8.8 Biodiversity

Hanna Swamp

Figure 15: Outline of Hanna Swamp¹³³

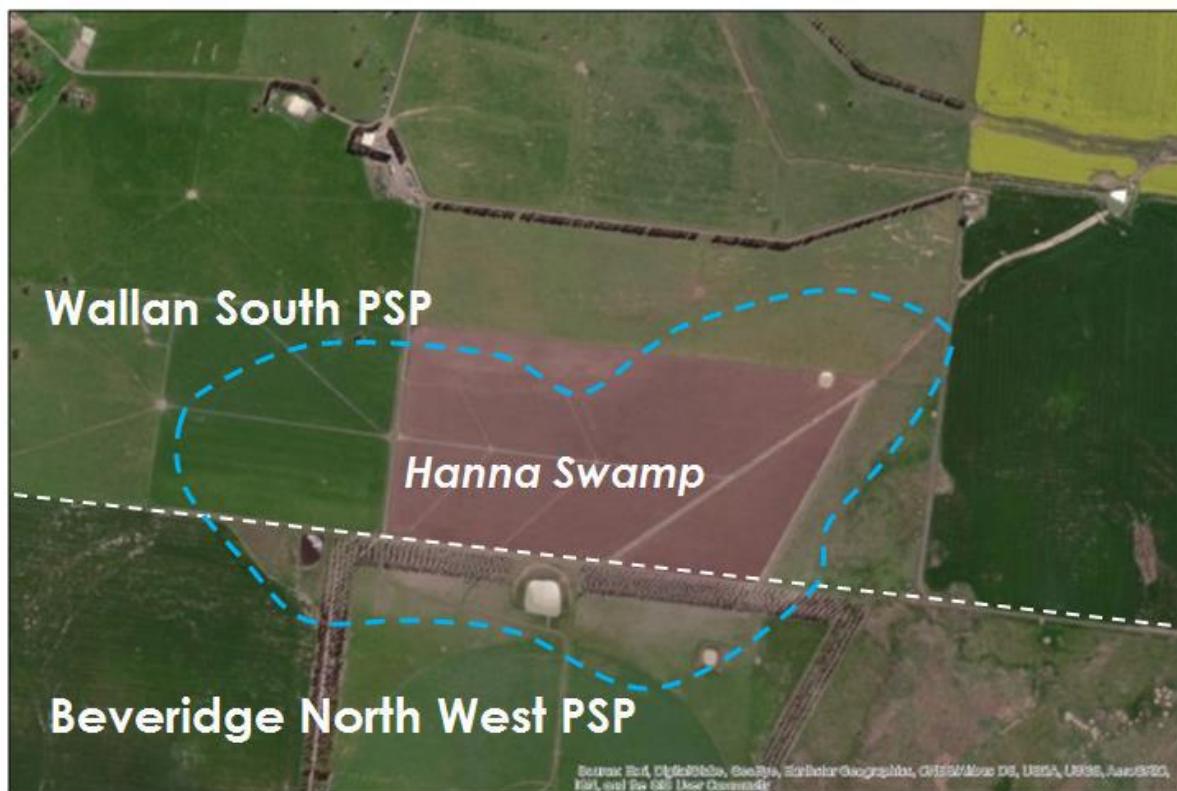
Most of the wetland area is north of the proposed Hadfield Road in the Wallan South PSP (see Figure 15). The PSP, while recognising it exists, does not specifically plan for it or include it on the high level integrated drainage plan (Plan 11). Most of the PSP drains to the south and thus understandably the main attention on drainage has been focused in that direction.

FOMC made extensive submissions about the history of the wetland, its current condition, and the potential for it to be recognised and planned for in the PSP. It submitted that earlier open space planning for the corridor explicitly recognised the wetland and made provision for it to be included in an integrated open space network.¹³²

FOMC made extensive submissions about the restoration potential for the wetland and the biodiversity¹³⁴, social, landscape and water quality benefits that might result. It also took the Panel through a review of state policy and the Planning Policy Framework to submit that developing the wetland would be inconsistent with policy.

It is not clear why Hanna Swamp has been overlooked for consideration in the PSP. Not being identified in the Melbourne Strategic Assessment does not provide sufficient justification given the broad range of state, regional and local planning policy that points to wetland protection and restoration.

The Panel is not able to say that all of Hanna Swamp must be protected. As noted a significant portion of it is in the Wallan South PSP. However, the Panel does consider there should be further investigation of how Hanna Swamp might be protected, and its natural values restored and utilised in planning for both PSPs. To do otherwise would be a significant lost opportunity.

- That part of Hanna Swamp in the Beveridge North West PSP should be more clearly identified and actively planned for to ensure the opportunities for wetland and waterway management and habitat restoration are not missed.
